QUANTA  
COMPUTER

<b>QUANTA COMPUTER</b>		<b>Change History</b>	
File	Document Number	Rev	3A
Size	C	AMD	
Date	Saturday, March 20, 2010	Sheet	34 of 34

PROJECT : NE8

CHANGE LIST 2

Title **CRT/LVDS**

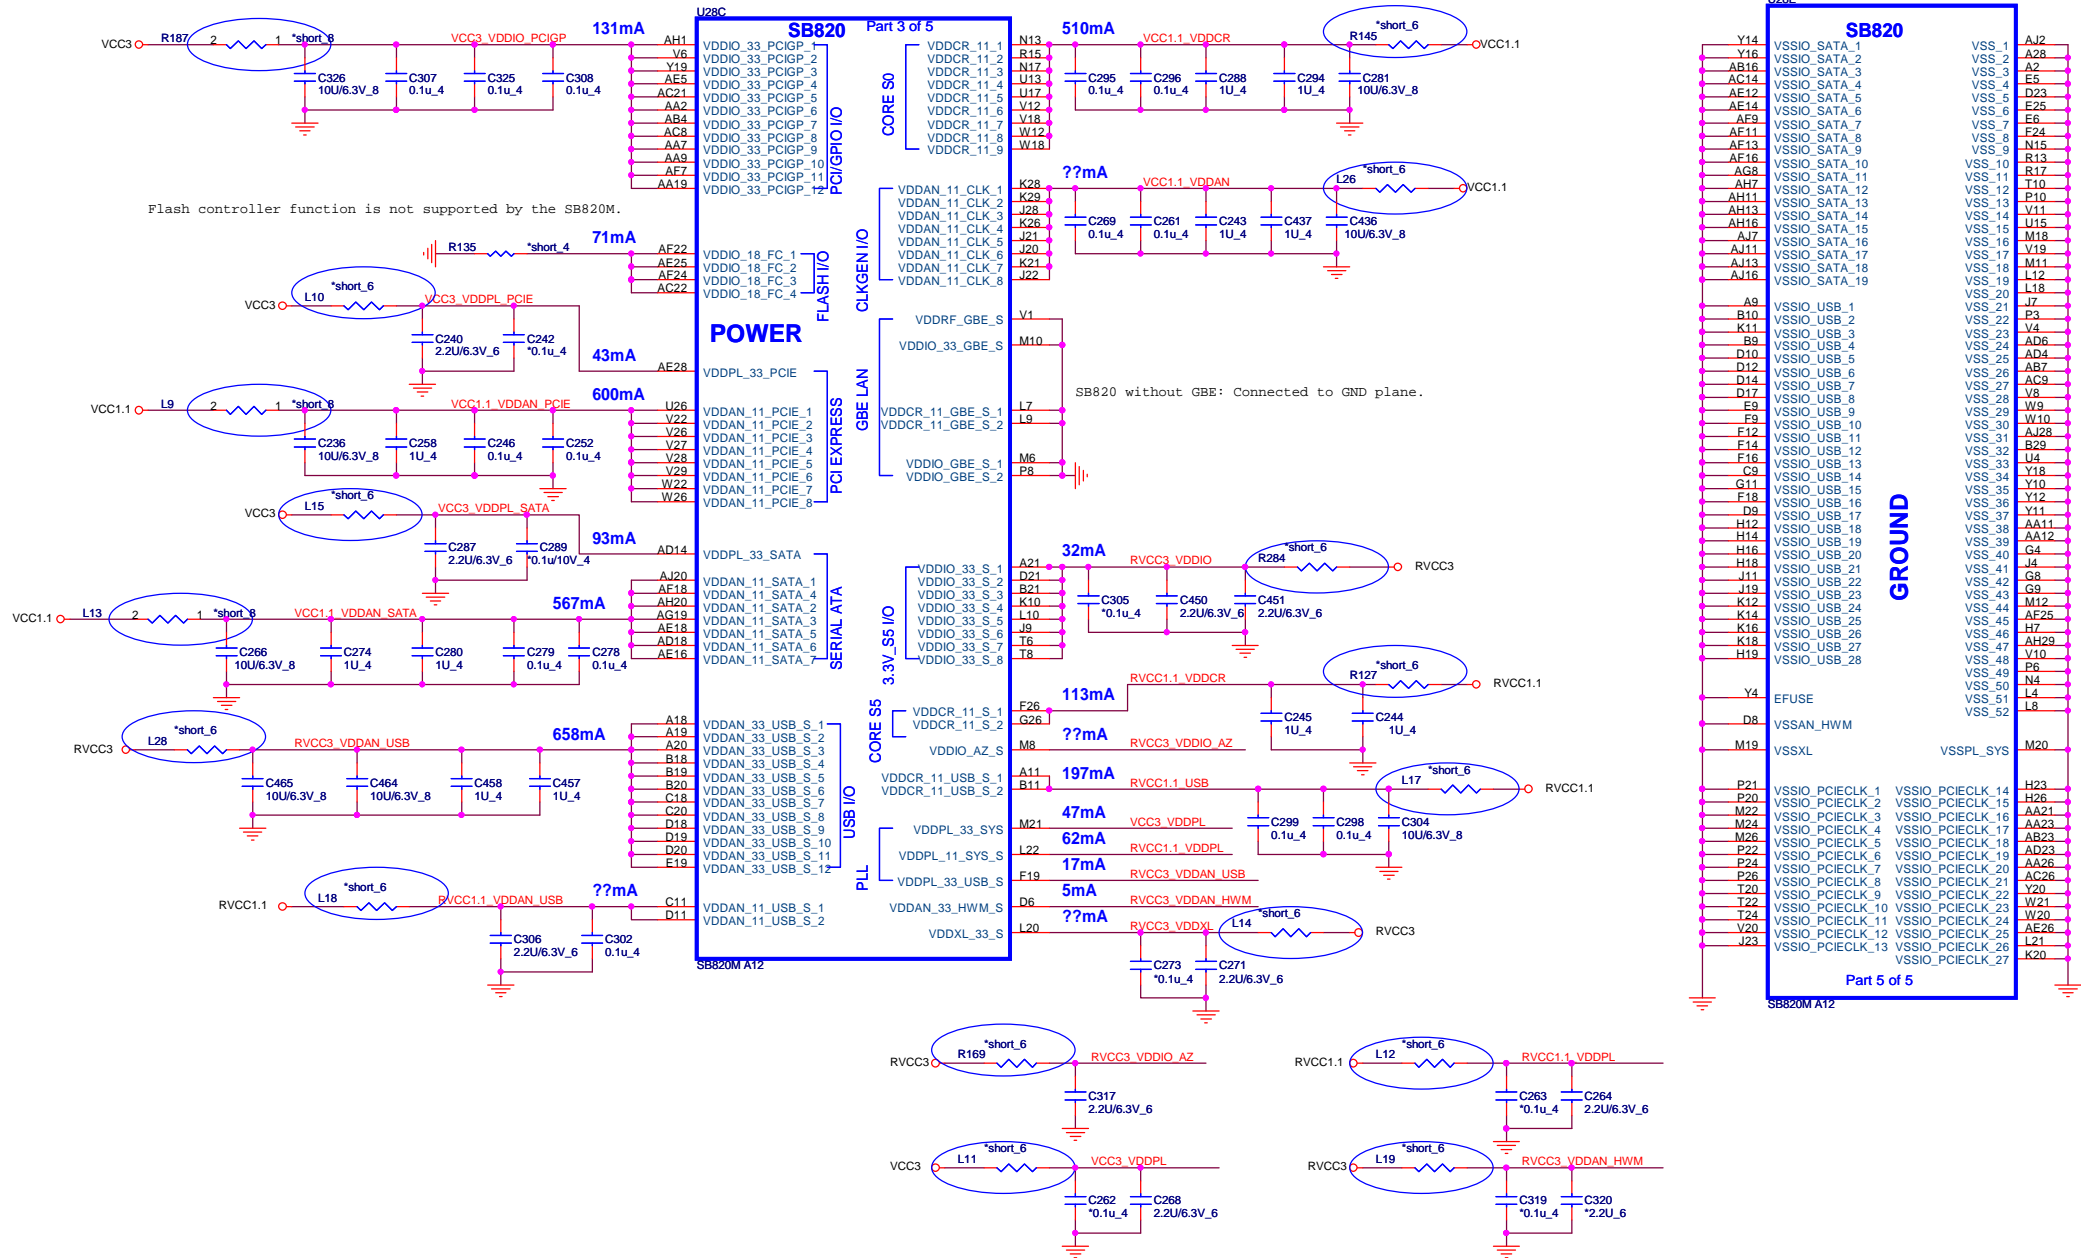
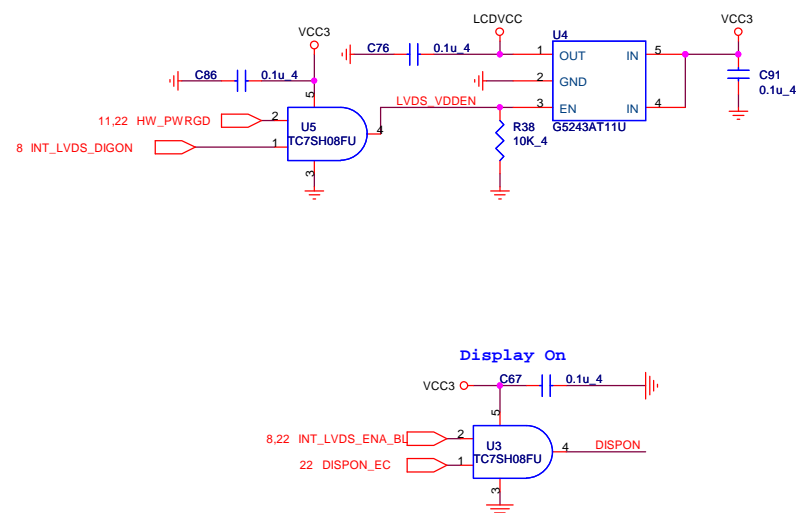
```
3A Remove Panel ID      3A :delete RP27,SW1,RP25
```

3A:Change R187,L10,L9,L15,L13,L28,L18,R169,L12,L11,L19,L14,L17,R127,R284,L26,R145 to short pad

3A: change power source for CRT port

Title		
HDMI		
Size B	Document Number	Rev 3A
AMD		
Date: Saturday, March 20, 2010		
Sheet 16 of 34

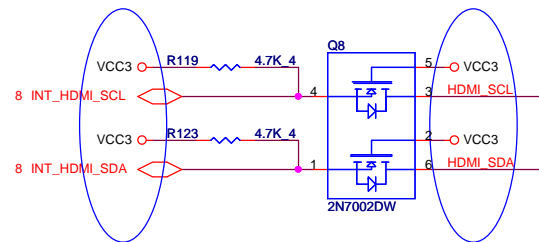
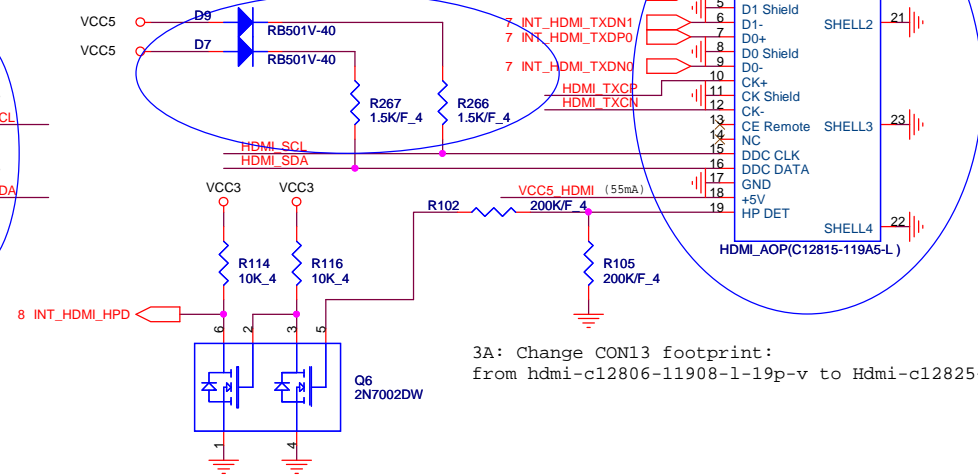
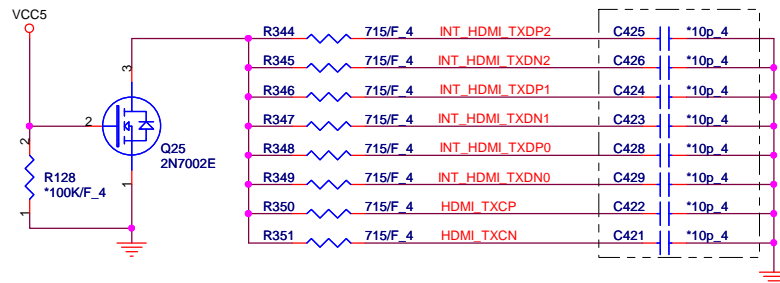
3A: change power source for  
HDMI port

3A:delete RP38

3A : VCC5 -&gt; VCC3

3A:Prevent incorrect voltage level

3A: Change CON13 footprint:  
 from hdmi-c12806-11908-1-19p-v to Hdmi-c12825-11908-1-19p-v

<b>QUANTA COMPUTER</b>			
Title			
Express Card/LED/BT			
Size	Document Number	Rev	
Custom	AMD	3A	
Date	Saturday, March 20, 2010	Sheet	19 of 34

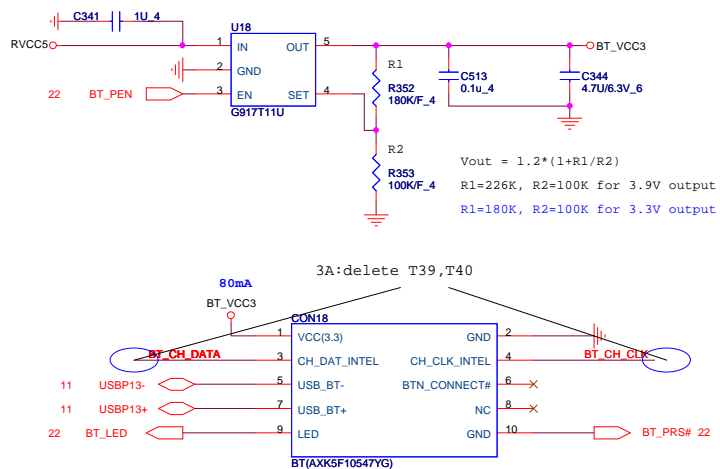
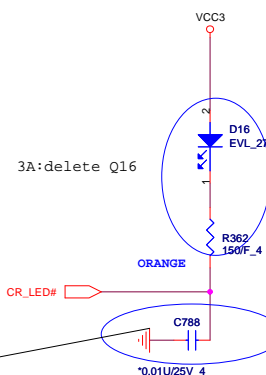
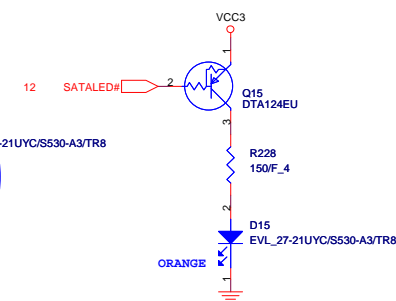
3A : Reverse C786, C787, C788 FP for ESD

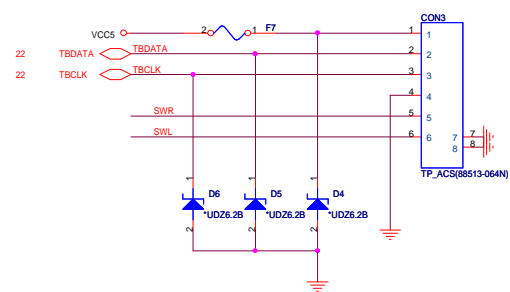
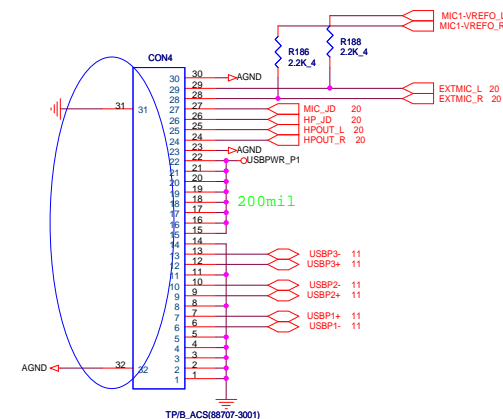
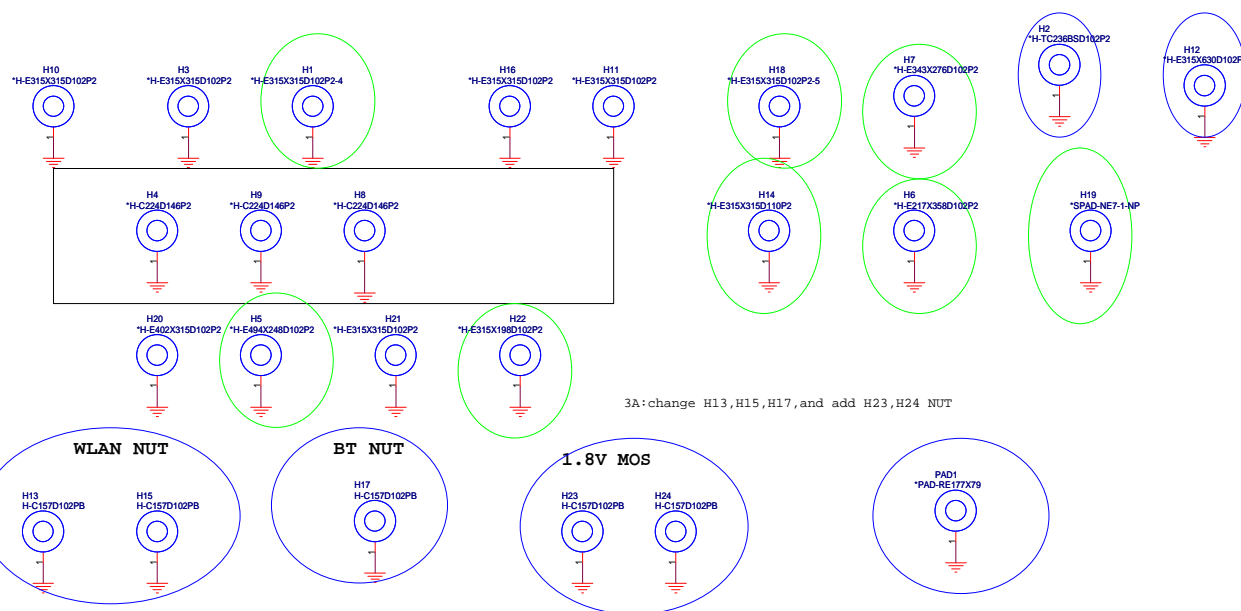
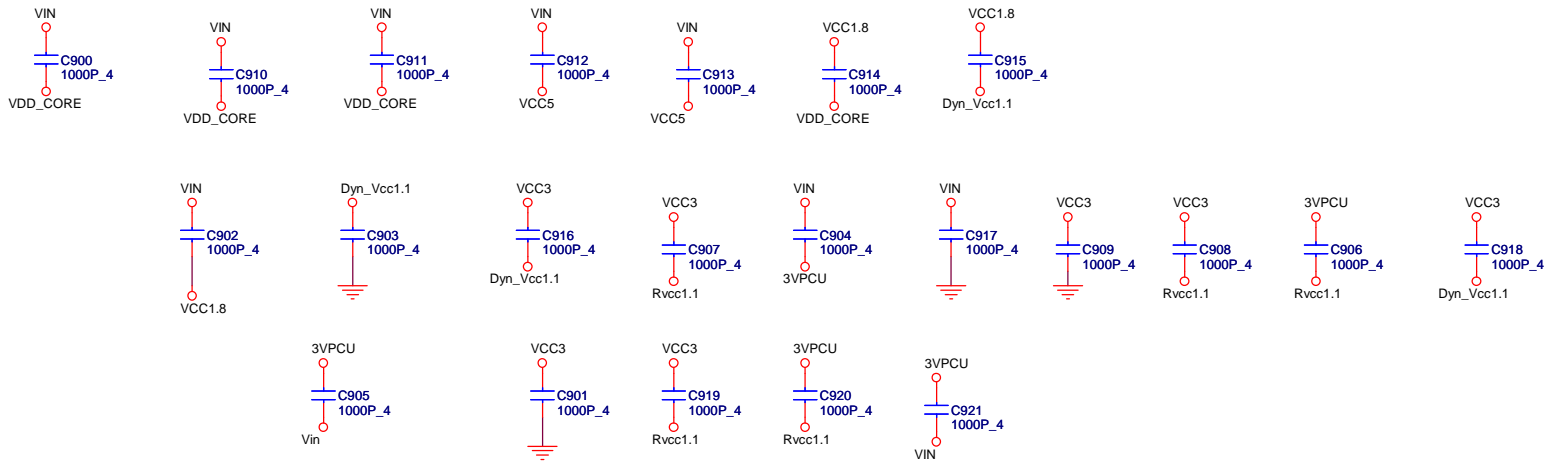
3A: change R236, R237 from 150 ohm to 75ohm for two color LED

3A change from 88511-3001 to 88707-3001

3A: change H13, H15, H17, and add H23, H24 NUT
